MID-CONTINENT AIRPORT

SANITARY SEWER SYSTEM

FOR
NORTH CARGO RAMP AREA

RECORD DRAWING

SITE PLAN

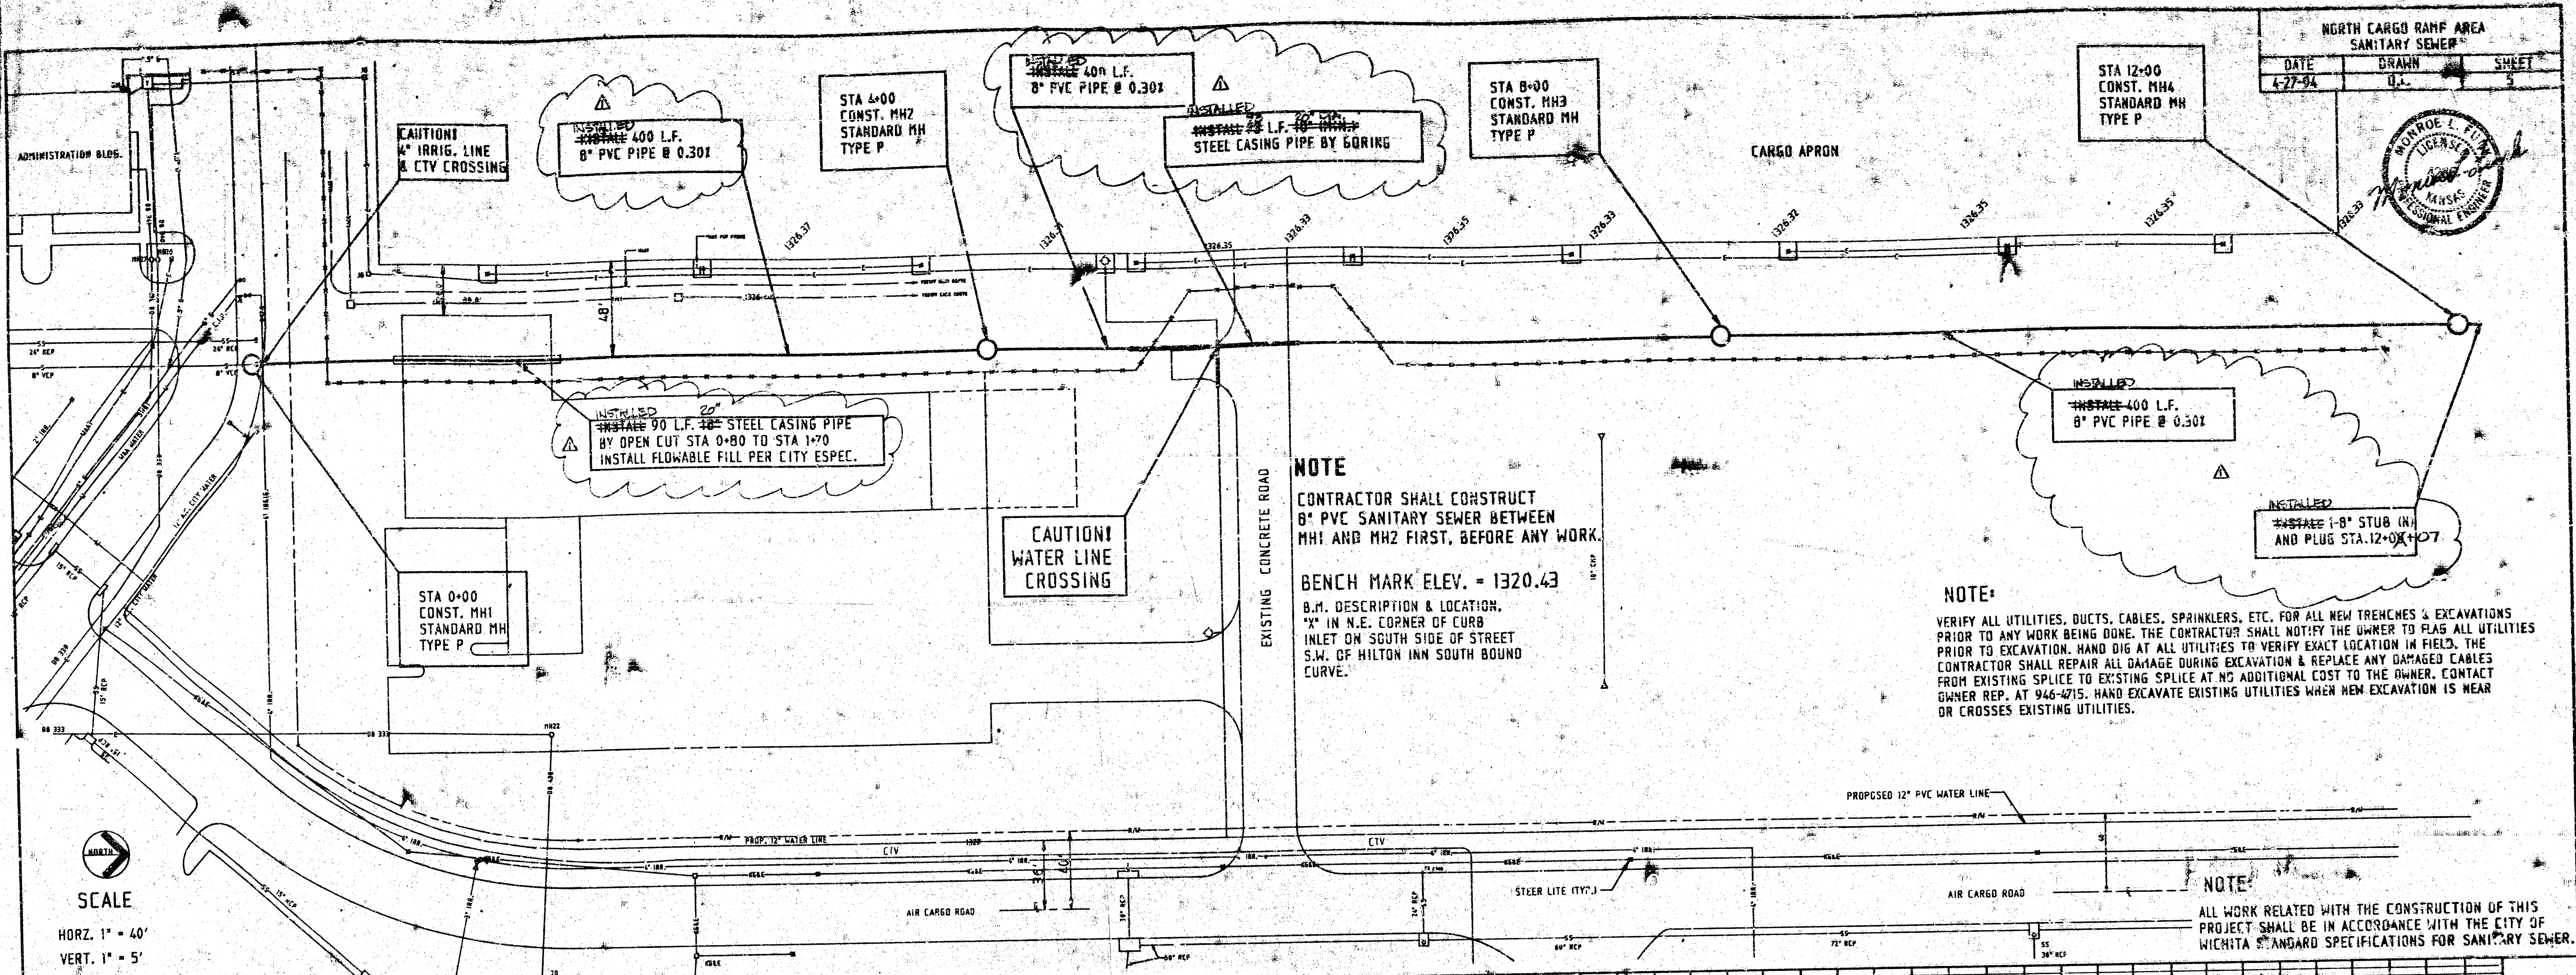
SHEET NO.	TITLE
1	TITLE SHEET
2	SITE PLAN - SUMMARY OF QUANTITIES, INDEX AND GENERAL NOTES
~~3~~	~~UNITED LINES 1 AND 2 - PLAN AND PROFILE~~
~~4~~	~~STANDARD WATER ASSEMBLY DETAILS~~
5	SANITARY SEWER PLAN AND PROFILE
6	SANITARY SEWER MH DETAILS
7	MANHOLE FRAME AND COVER DETAIL

ITEM	DESCRIPTION	UNITS	AS PROPOSED	AS BUILT
1	8" PVC SANITARY SEWER IN PLACE	LF	1,200	1,207
2	MANHOLE (TYPE P) IN PLACE	EA	4	4
3	18" STEEL CASING IN PLACE BY BORING	LF	~~150~~ 73	93
4	20" STEEL CASING IN PLACE BY OPEN CUT	LF	~~90~~ 90	90
5	~~12" PVC WATER LINE IN PLACE~~	~~LF~~	~~1,312~~	
6	~~8" PVC WATER LINE IN PLACE~~	~~LF~~	~~350~~	
7	~~8" VALVE ASSEMBLY~~	~~EA~~	~~1~~	
8	~~12" VALVE ASSEMBLY~~	~~EA~~	~~1~~	
9	~~12" JET TAP~~	~~EA~~	~~1~~	
10	~~FIRE HYDRANT IN PLACE~~	~~EA~~	~~3~~	
11	~~12" 80' CPM TEE~~	~~EA~~	~~1~~

15. INDEX AND SUMMARY OF QUANTITIES ARE REVISED PER APPLICABLE PROJECT DRAWINGS. PROJECT DRAWINGS ARE SEPARATED INTO TWO SETS FOR RECORD DRAWINGS.

△ REVISED 9/7/94 C. W.A.A.
